129-18-CA

412 KINSEY STREET  
BOYLAN HEIGHTS  
HISTORIC DISTRICT (HOD-G)

## APPLICATION FOR A CERTIFICATE OF APPROPRIATENESS – STAFF REPORT

Nature of Project: Implement master landscape plan; install fence; alter driveway; remove trees

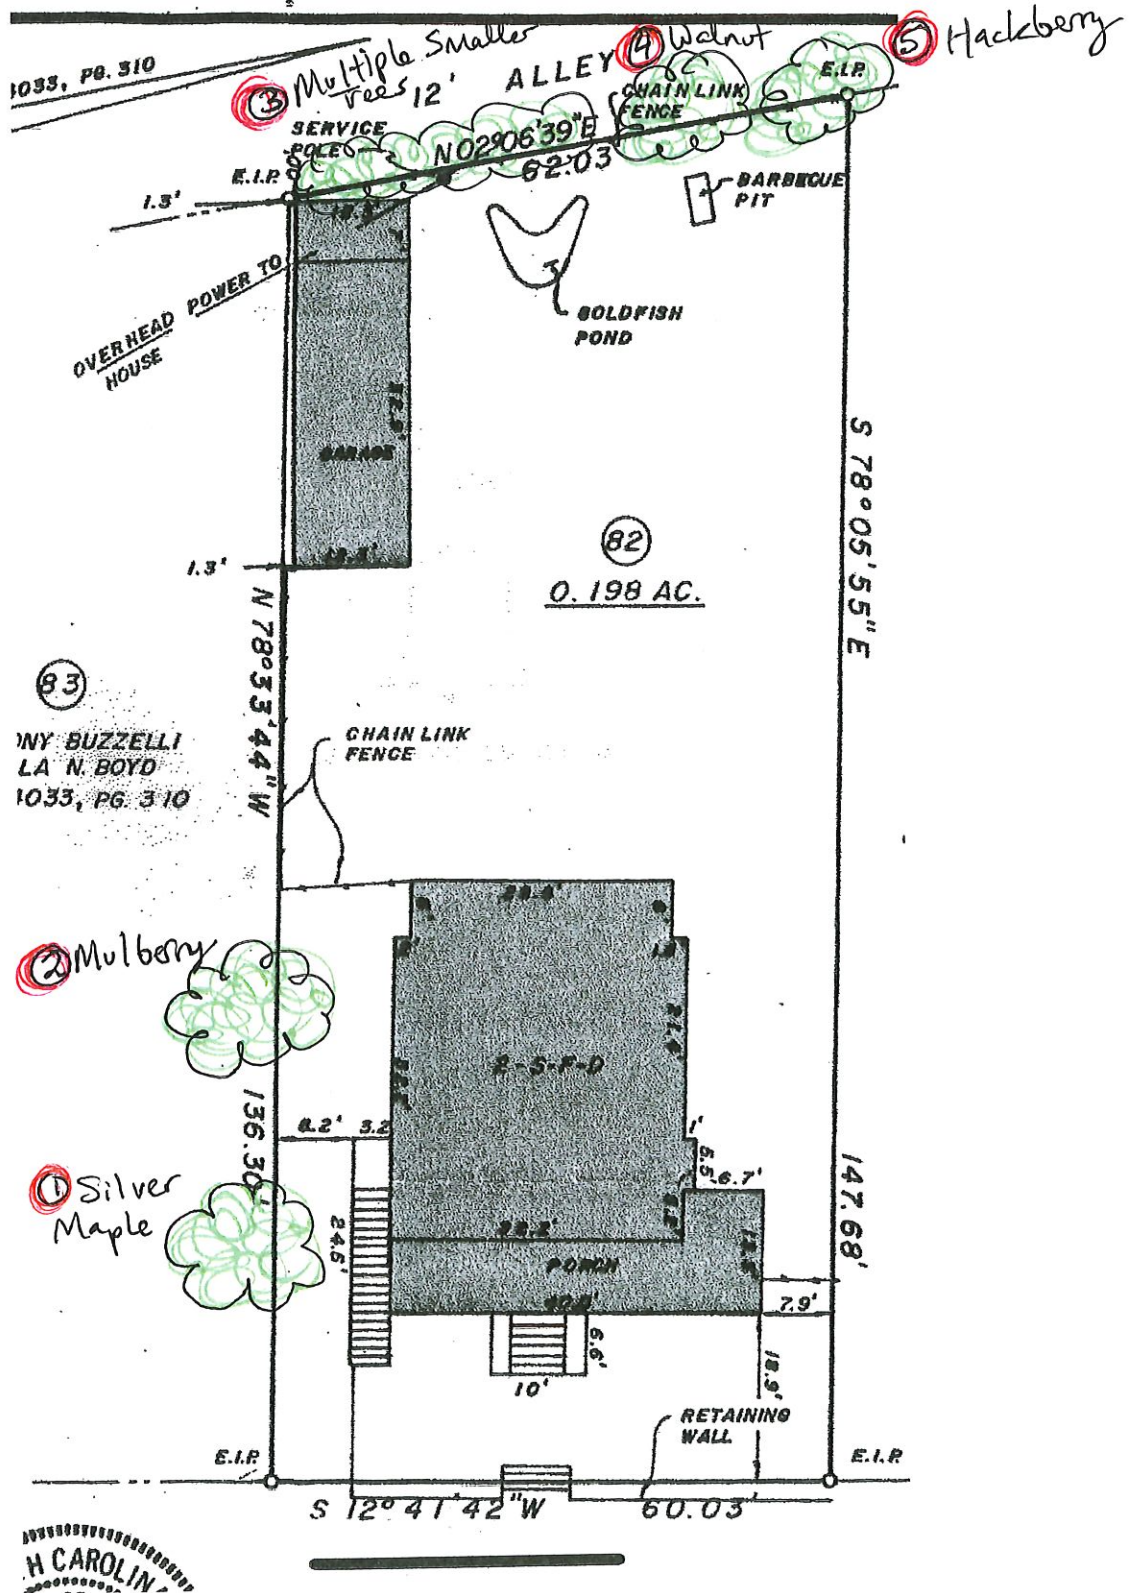
#	Tree Species	Objectives and Specifications (See back for definitions, terms, and conditions.)	Qty	Cost
1	Multiple Trees	<p>Health/Hazard Assessment General assessment for several trees around property.</p> <p>①: Silver Maple to left of house (31" DBH)— Maple is in overall good health with no major signs of decline. Many longer larger limbs extend over adjacent parking area and cars. Tree is growing onto customers house causing issues with siding. Larger section of critical root mass extends over to house foundation and may be causing damage to foundation. Exposed root mass has already destroyed previously laid concrete driveway strips.</p> <p>②: Mulberry to left of house (19")-- Tree is in decent health. There is a large amount of understory deadwood in this tree hanging over customers driveway area as well as adjacent parking area on neighboring property. Tree is also growing into customers house causing siding and roof damage. Trees roots are extending over toward house foundation and have already caused severe damage to existing concrete driveway strips.</p> <p>③: Several Ligustrum (&lt; 6-8" DBH) and such at back fence line-- Most if not all of these trees are volunteers. Two trees/shrubs growing near back of barn have caused severe structural damage to adjacent patio wall and foundation at back of barn area. Almost all of these trees/shrubs are growing into and around the existing chain link fence and are slowly consuming said fence. Any replacement fence will too be destroyed by these volunteers of installed.</p> <p>④: Walnut at back fence line (18" DBH)— Walnut has an abnormal rot pocket about twenty five feet up main trunk. This rot pocket could be negatively affecting the structural integrity of the trunk in that location. Otherwise tree seems to be in decent health.</p> <p>⑤: Hackberry at back fence line (28" DBH)— Hackberry appears to be in decent health. Two previous large stem failure wounds are present on trunk which could indicate internal issues with trunk integrity. Previous co-dominant stem about twenty feet up main trunk tore off several years ago. Previous large stem failures can increase risk of future stem failures in the same tree.</p>	1	\$100.00

ECO DUBLIN®  
CLASSIC

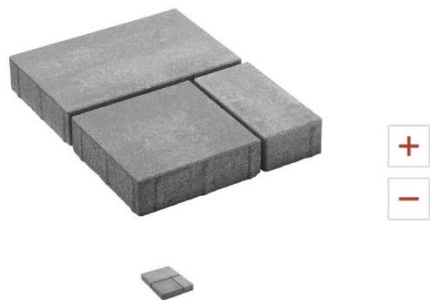
1\* The applicant proposes the alteration of the driveway. The existing concrete strips are in poor condition. The application drawings indicate that brick paver strips are proposed; however, in an email from the applicant, a full brick driveway is preferred. The proposed bricks are permeable pavers that will match the existing brick retaining wall in the front yard in appearance. Images of the proposed bricks were provided.

2\* Full brick driveways are atypical in Boylan Heights. The Boylan Heights Special Character Essay states: "When not adjacent to alleys, driveways are most often gravel or concrete ribbon strips, squeezing beside the house to access the rear yard, and pushing the house close to the opposite side-lot line."

1. Please provide us with material information for: the sitting wall (brick? stone? etc...) and steps; the pavers for the patio and driveway; and the rain barrel or silo

We think the driveway may look better in a water permeable paver with a brick appearance, to complement the natural brick retaining wall in the front yard, which is also visible from the street. Also the foundation of the house is a painted brick, also visible from the front of the house. The Belgard Eco Dublin in Ashbury Haze finish seems to be the best complement to the existing brick. We prefer to complete the driveway as a solid piece (not a pair of ribbons).

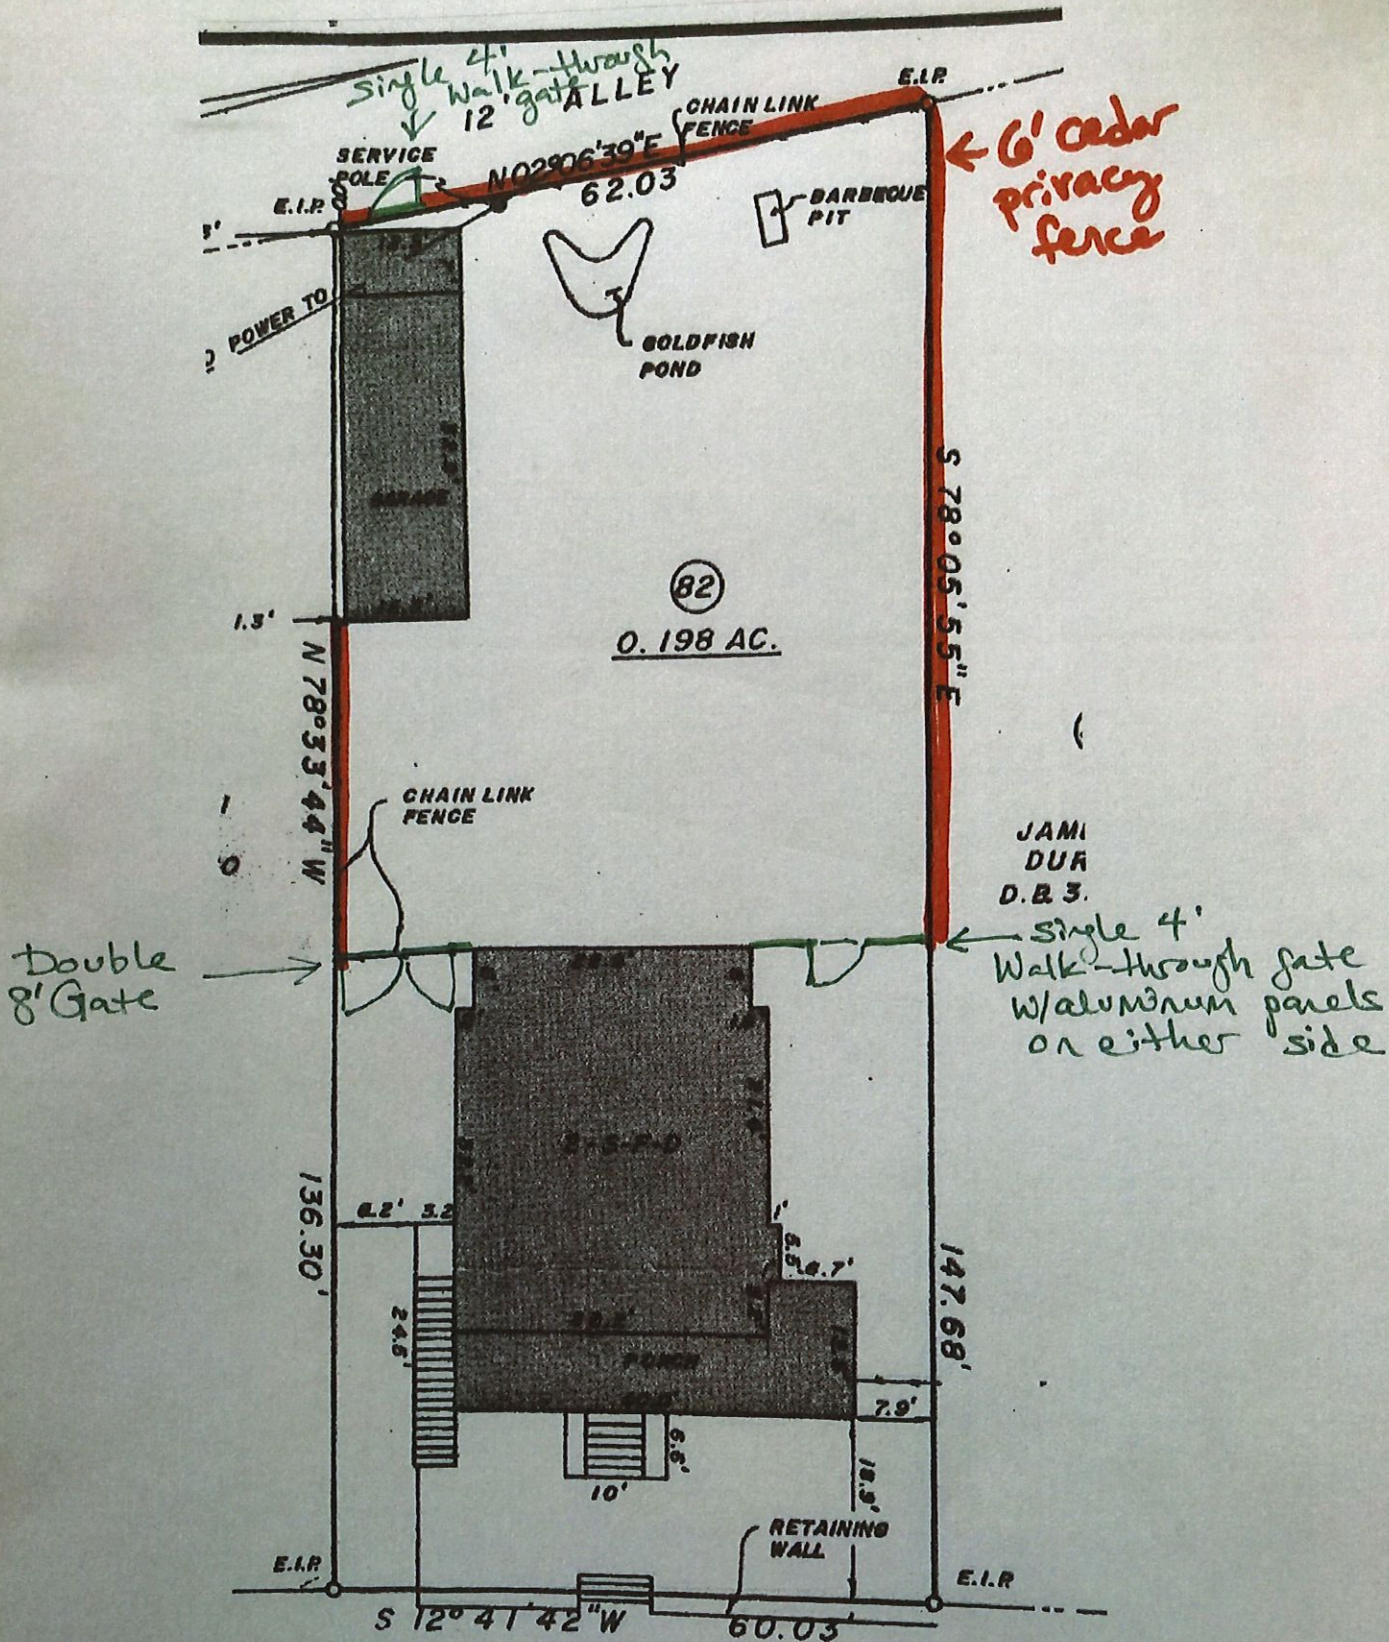
6. Please submit a drawing that shows where the fence will be located. Will it be replacing the current chain link? What will it look like?
7. Will the potted herbs along the driveway be placed on a paver or concrete pad? If no, there's no need to show them on the drawings.

6. The new wood back yard privacy fence will be 6' dog-eared privacy fence in cedar, with no space between 1" x 6" pickets. All 4" x 4" posts will be set with postmaster system and Japanese cedar. Rails will be 2" x 4" with three per section. It will replace the current chain-link, which is severely damaged.

Black aluminum metal gates and panels on either side of the rear corner of the house have been suggested to increase pedestrian visibility of the back yard from the street. Fence will only provide visual privacy on sides and rear of property. There would be a 8' double gate on the left hand driveway side of the house, and a 4' walk gate on the right hand side. Also a 4' wall gate towards the back of the shed at the rear of the property to access the alleyway. I've attached photos showing examples of cedar fence style, and gate style. Also a map showing location of wood fencing and metal gates.
